# Safety Evaluation Report

## Related to the License Renewal of the R.E. Ginna Nuclear Power Plant

Docket No. 50-244

February 2004

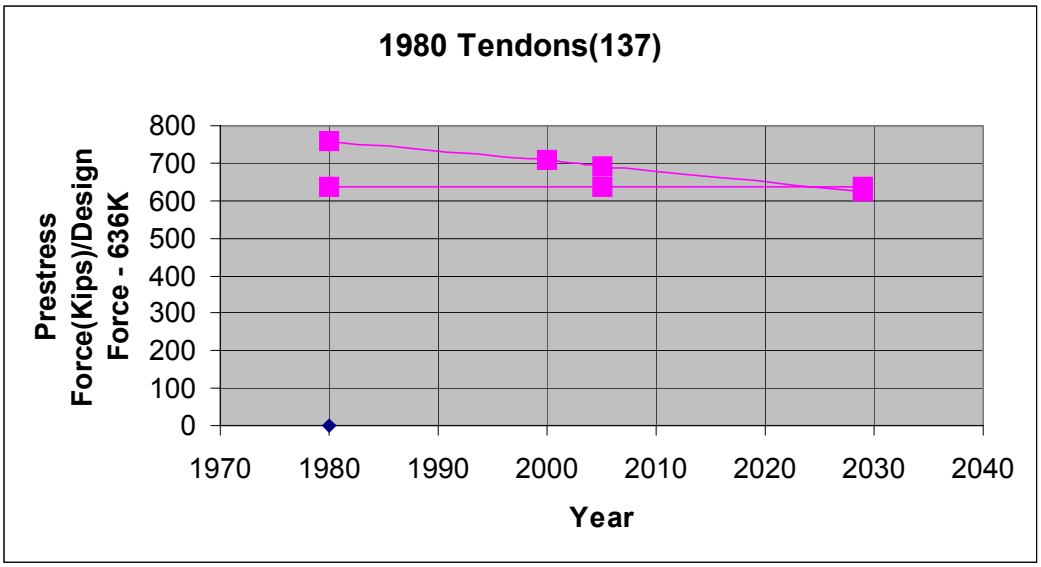
In response, the applicant provided the following information:

a) Based on the available test information for this set of 137 tendons that were retensioned in 1980, the below graph shows the trend line from 1980 projected through 2005, and out to 2029. The graph also includes a constant line at 636 kips, which is the minimum design prestress force.
